UNITED STATES PATENT AND TRADEMARK OFFICE

Office Action Summary

10/524,864

DETAILED ACTION

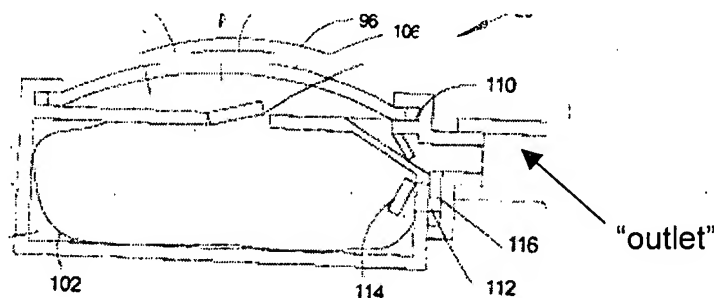
5. Claims 1-4, 6, 9-16 and 22-24 are rejected under 35 U.S.C. 102(e) as being anticipated by Meah (U.S. Patent No. 6,432,040). Meah discloses an implantable sphincter capable of surround the stomach of a patient. Regarding claims 1 and 22-24, Meah teaches an adjustable band to be placed over the first part of the stomach adjoining the esophagus. The band has an internal inflation chamber to be increased or decreased thereby adjusting the tightness of the device (col. 2, lines 15-21). The inflation device has a fluid reservoir for providing fluid to the inflatable chamber (col. 2, lines 47-50). A first valve **110** is between the fluid reservoir **102** and the inflatable chamber of the band (sphincter body comprising the adjustable band) for expanding the sphincter body (col. 6, lines 4-15 and Fig. 6). A second valve **114** is between the inflatable chamber and an "outlet" (see depiction below).

A "controller," or diaphragm **96** actuates the valves, thereby increasing or decreasing the amount of fluid introduced into the sphincter body for adjusting its opening and thus imposing a tighter fit on the organ. The reservoir is further capable of having a pressure that remains greater than or equal to the pressure in the inflatable chamber. The "controller" **96** is remotely controllable from outside the patient since the patient can physically press on the "controller" located under the skin of the patient (col. 6, lines 9-

Regarding claim 10, the "outlet" as construed in claim 1, is also considered to be a "waste reservoir" since no further structure is provided in the claim language. In view of claim 11, since the fluid flows from an area of high pressure in the fluid reservoir **102** through valve **114** to the "outlet" (refer back to depiction above), the "waste reservoir," which constitutes the "outlet," is considered to be "negatively pressurized."
